Access Compliance Report Public Rights-of-Way (Curb Ramps)

Intersection ID: 27236 Main Street: BALLANTYNE_CORPORATE_PCross Street: BRIXHAM_HILL_AV Location: NE **ADA ID: DE18ED7B7AC5** Ramp Type: Perp Initial Pass/Fail: Fail **Overall Compliance: No Severity Score:** 10

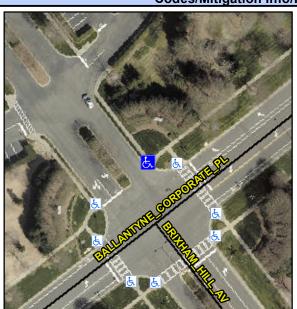
BRIXHAM HILL AV Street 1 Name Stop Condition-Street 2 StopSign Street 2 Name N/A Stop Condition-Street 1 N/A Possible Solutions: Remove & Replace Entire Ramp. Surveyor Notes: N/A PROW/ADA: Not Found, R304.5.1, R304.5.3

Field Measurements/Component Compliance						
Compliance Description		Data	Comp	liance	Description	Data
N/A	Ramp Length (in)	88.0	Yes	Ramp	Slope (%)	5.6
No	Ramp Width (in)	44.0	No	Ramp	XSlope (%)	4.1
N/A	Flare Type LT	N/A	N/A	Flare	Type RT	N/A
N/A	Flare Slope LT (%)	N/A	N/A	Flare	Slope RT (%)	N/A
N/A	Flare Traversable LT?	N/A	N/A	Flare	Traversable RT?	N/A
N/A	Landing Length (in)	N/A	N/A	DWS	Provided?	N/A
N/A	Landing Width (in)	N/A	N/A	DWS	Contrast?	N/A
N/A	Landing Slope (%)	N/A	N/A	DWS	Length (in)	N/A
N/A	Landing X Slope (%)	N/A	N/A	DWS	Full Width?	N/A
N/A	Landing Curb? (Y/N)	N/A	N/A	DWS	Offset (in)	N/A
N/A	Shared Landing?	N/A				
N/A	Gutter Ponding?	N/A	N/A	Gutte	er Slope (%)	N/A
N/A	Gutter Lip Ht (in)	N/A	N/A	Gutte	er X Slope (%)	N/A
N/A	Painted X Walk1?	No	N/A	Paint	ed X Walk2?	N/A
	X Walk 1 Direction	To SW		X Wa	lk 2 Direction	N/A
N/A	X Walk 1 Width (in)	N/A	N/A	X Wa	lk 2 Width (in)	N/A
	X Walk 1 Slope (%)	0.4		X Wa	lk 2 Slope (%)	N/A

X Walk 1 X Slope (%)	0.1		X Wa	lk 2 X Slope (%)	N/A
N/A	Ramp inside XWalk1?	N/A	N/A	Ram	o inside XWalk2?	N/A
	Road Slope (%)	N/A	N/A	Clear	Space?	N/A
	Road X Slope (%)	N/A	N/A	Clear	Space to XWalk (in)	N/A
N/A	Any Obstructions?	N/A	N/A	Storn	n Grate/Utility Hazard?	N/A
	Obstruction Type			Storn	n Grate/Utility Type	
		N/A				N/A
			Yes	Surfa	ce Condition? (G/P)	Good
